MIL-I-5488A
Amendment 2
5 June 1980
Superseding
Amendment 1
26 February 1963

INDICATOR, TURN AND SLIP, 28V., DC,
2-3/4 SIZE, TYPE MD-10

This amendment forms a part of Military Specification MIL-I-5488A dated 30 April 1957, and is approved for use by all Departments and Agencies of the Department of Defense.

FIGURE 1. DIAL AND POINTER MARKINGS

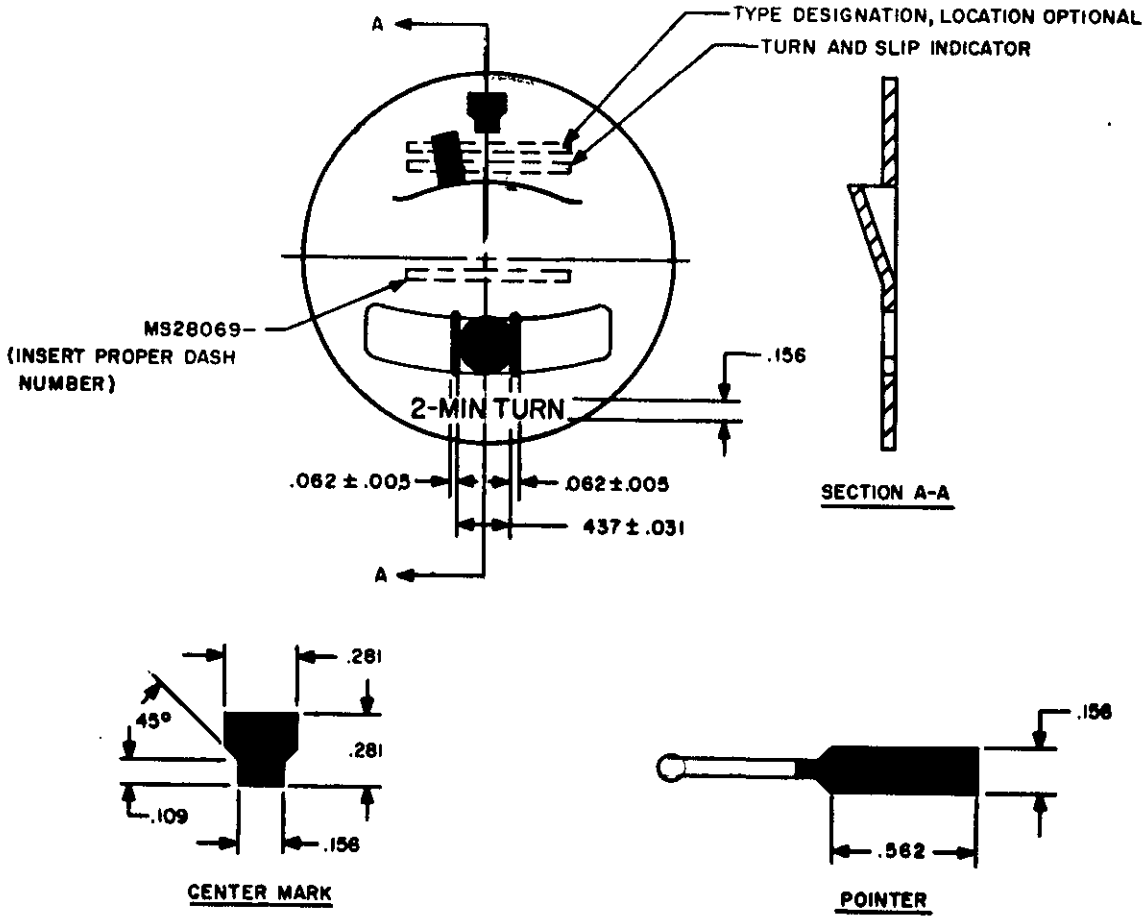
Delete "figure 1" and substitute attached "figure 1"
